DEVELOPMENT APPLICATION

Project Adress
91-93 MCINTO8H ROAD NARRAWEENA NSW 2099

09.18 DA ISSUE 01 02.19 AMMENDMENTS AS NOTED AND REISSUED TO COUNCIL 04.19 AMMENDMENTS AS NOTED AND REISSUED TO COUNCIL

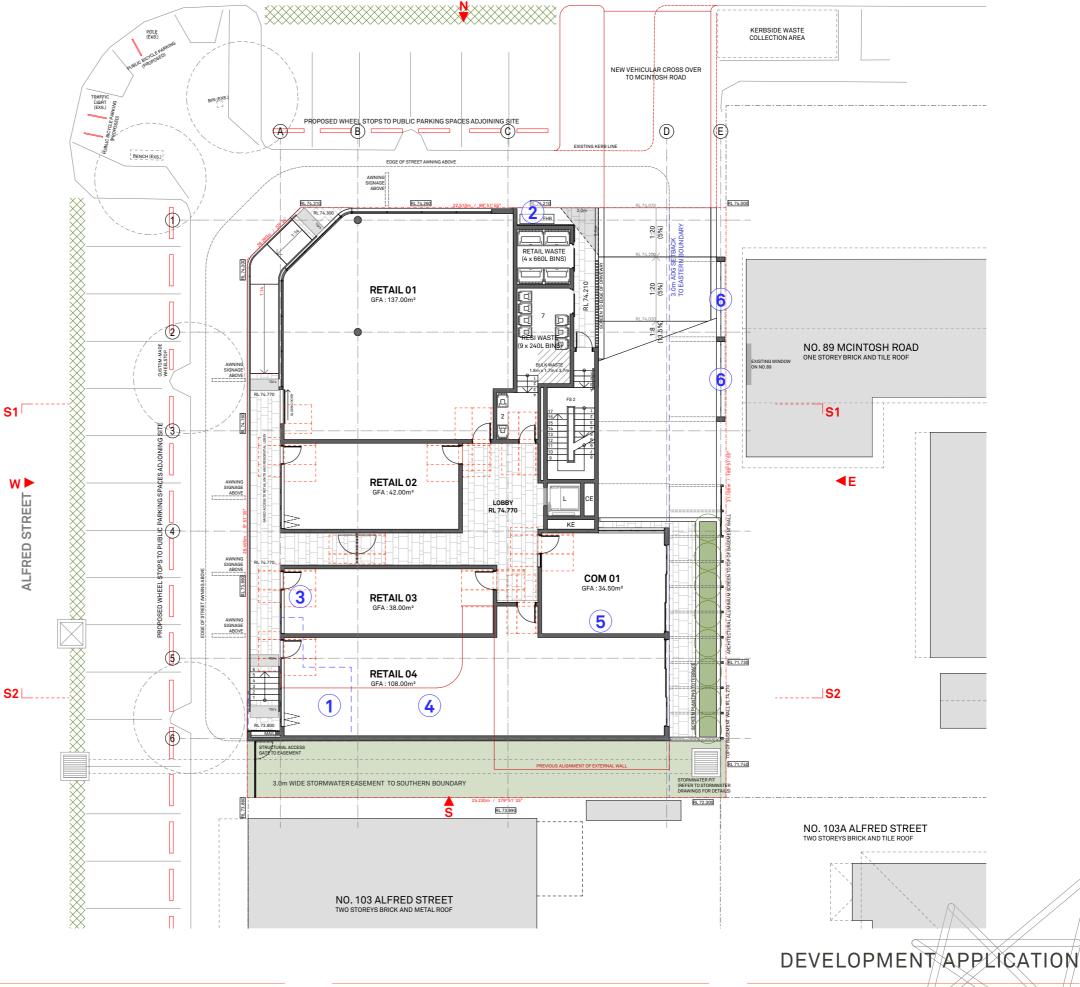
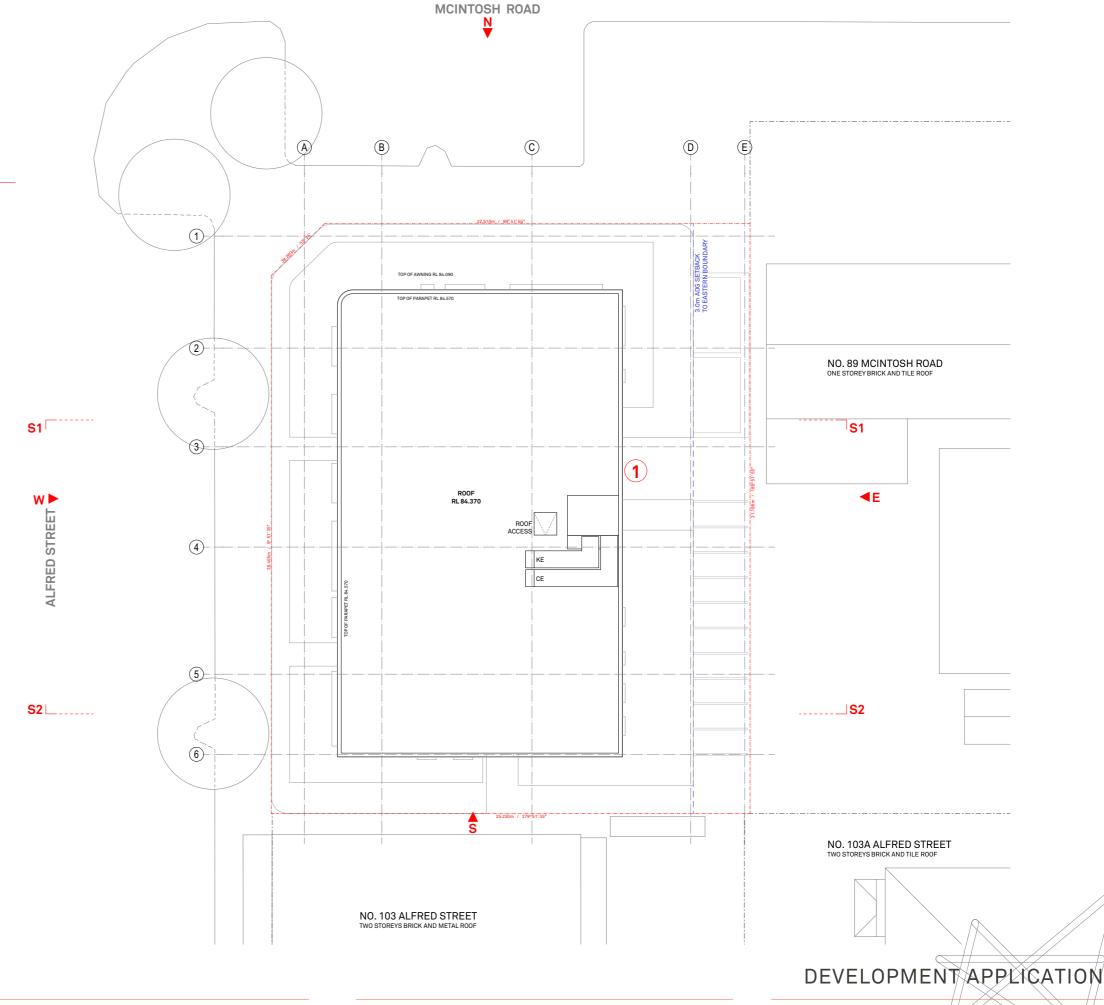
- 1. PREVIOUS LOCATION OF FIRE HYDRANT BOOSTER & FIRE STAIR 1
- 2. PROPOSED LOCATION OF FIRE HYDRANT BOOSTER
- 3. AMENDMENTS TO AREA AND FRONT FACADE OF RETAIL 03
- 4. PROPOSED AREA OF RETAIL 04
- 5. PROPOSED AREA OF COM1 AND REMOVAL OF COM 2
- 6. PROPOSED POLYCARBONATE ACOUSTIC BARRIER AT 2.2M (HEIGHT) x 4M (LENGTH) x 10MM (THICK) TO ACOUSTIC CONSULTANT SPECIFICATION

ROOF PLAN

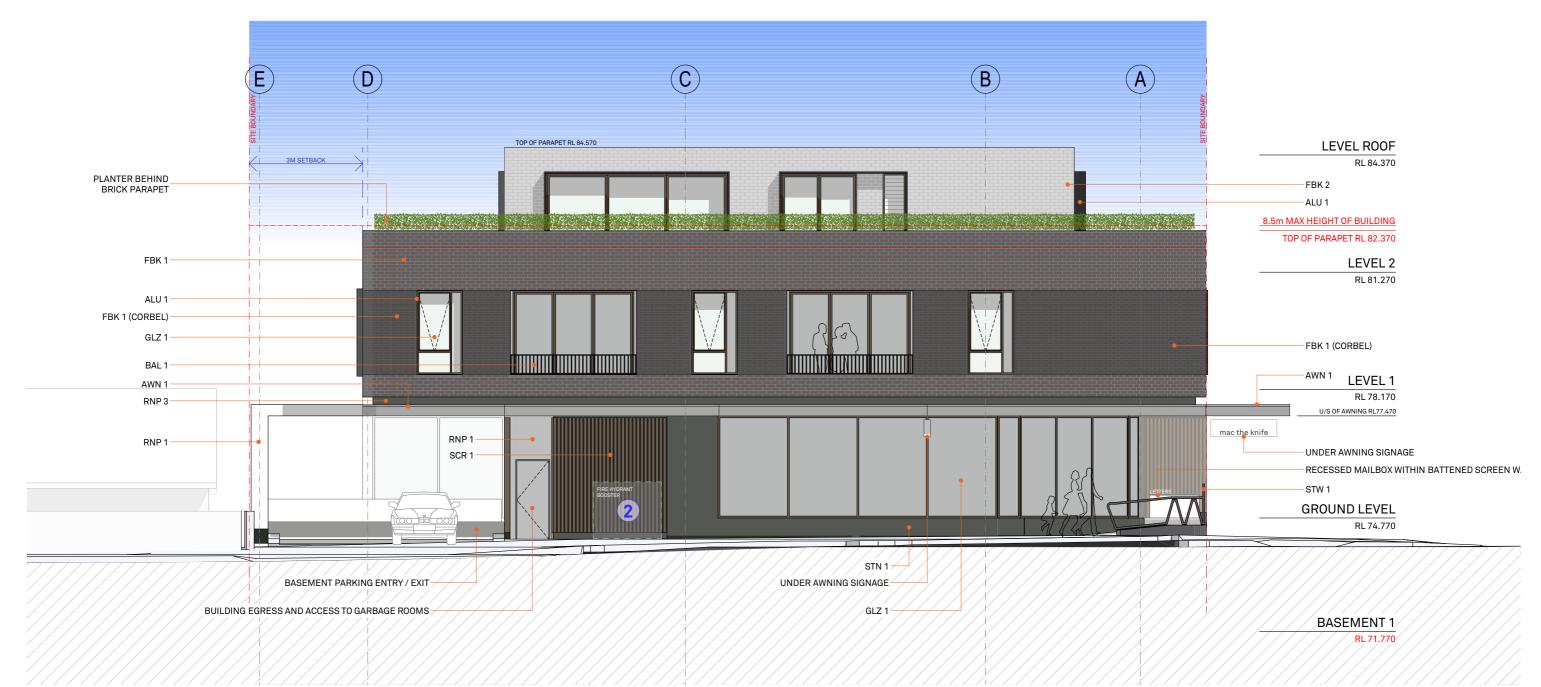
1. MINOR AMENDMENTS TO CORE CONFIGURATION AND ROOFTOP PLANT

PROJECT NO. DRAWING NO. DRAWING **EAST ELEVATION** ISSUE C

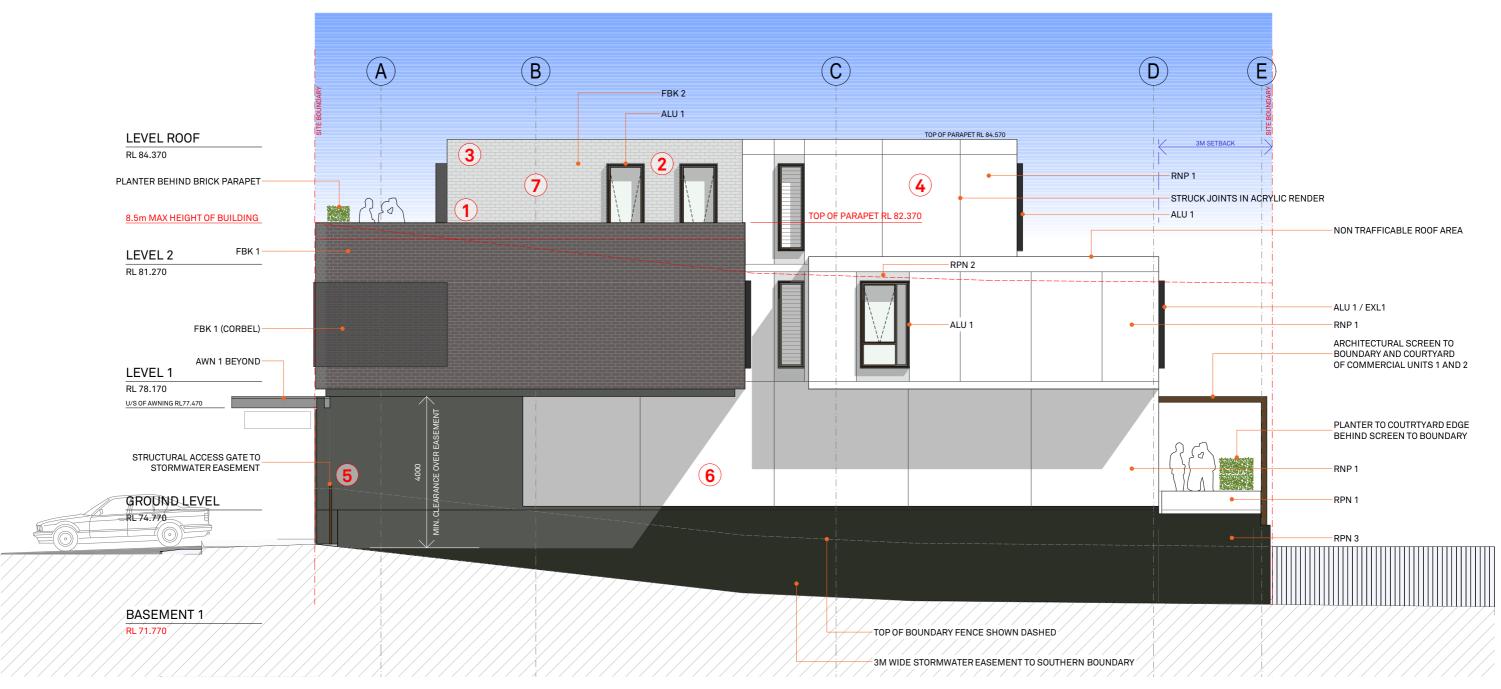
- 2. PROPOSED LOCATION OF FIRE HYDRANT BOOSTER
- 4. PROPOSED AREA OF RETAIL 04
- 5. PROPOSED AREA OF COM1 AND REMOVAL OF COM 2
- 6. PROPOSED POLYCARBONATE ACOUSTIC BARRIER AT 2.2M (HEIGHT) x 4M (LENGTH) x 10MM (THICK) TO ACOUSTIC CONSULTANT SPECIFICATION

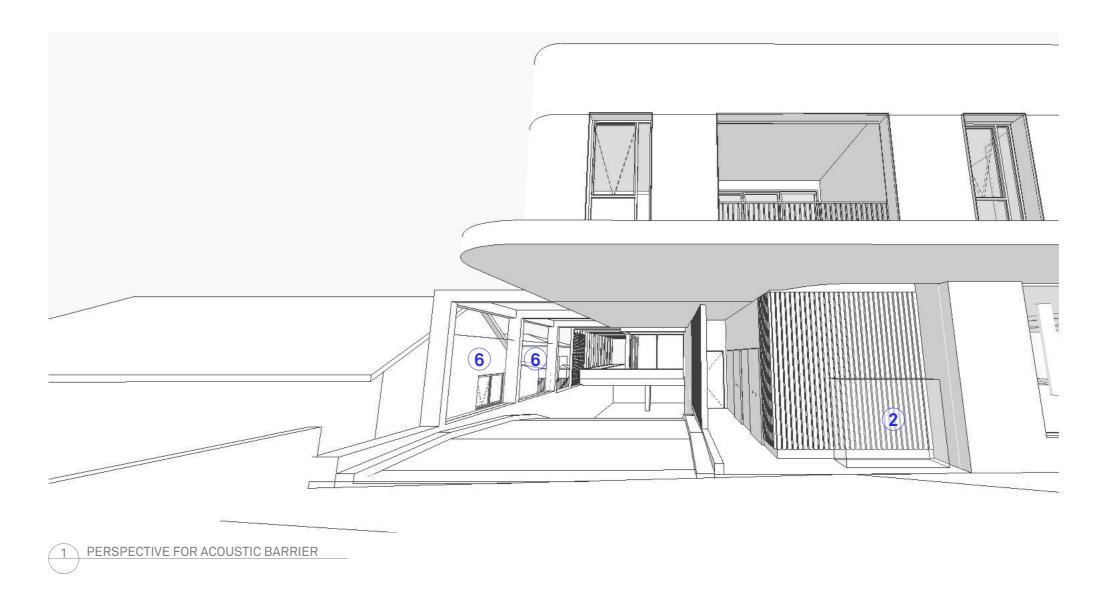
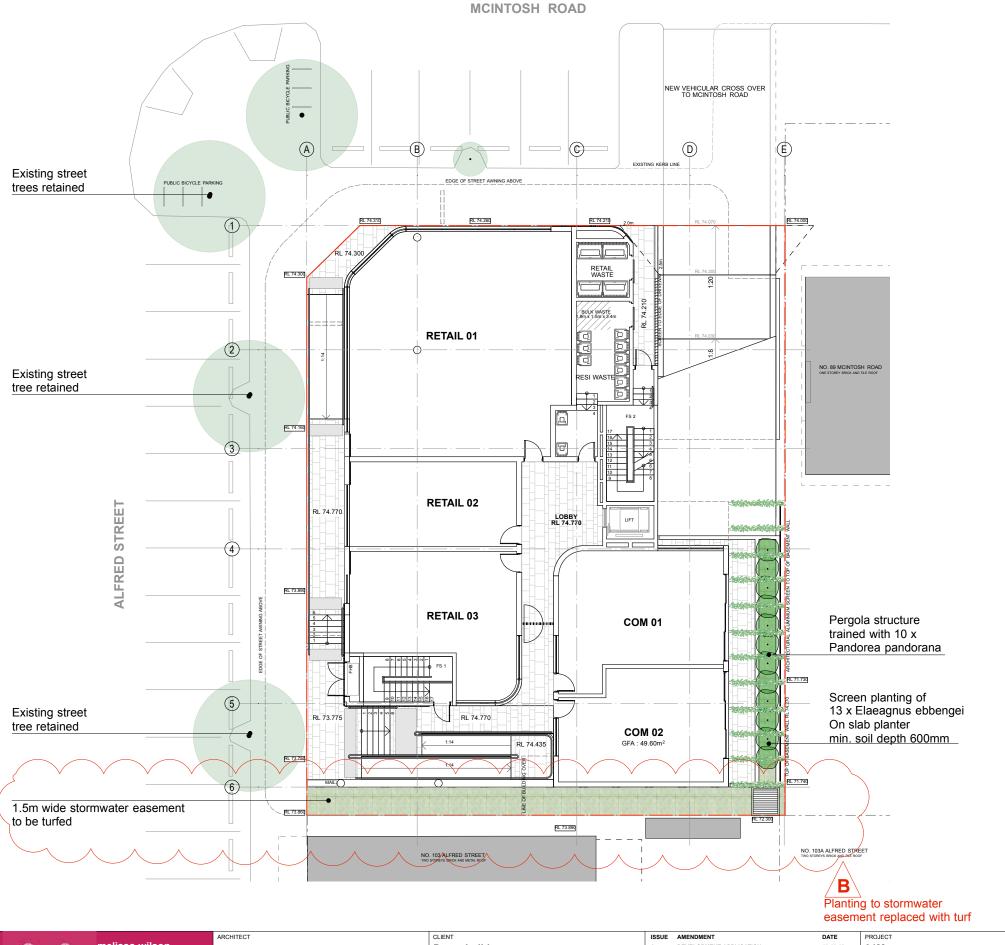
- 2. PROPOSED LOCATION OF FIRE HYDRANT BOOSTER
- 6. PROPOSED POLYCARBONATE ACOUSTIC BARRIER AT 2.2M (HEIGHT) x 4M (LENGTH) x 10MM (THICK) TO ACOUSTIC CONSULTANT SPECIFICATION
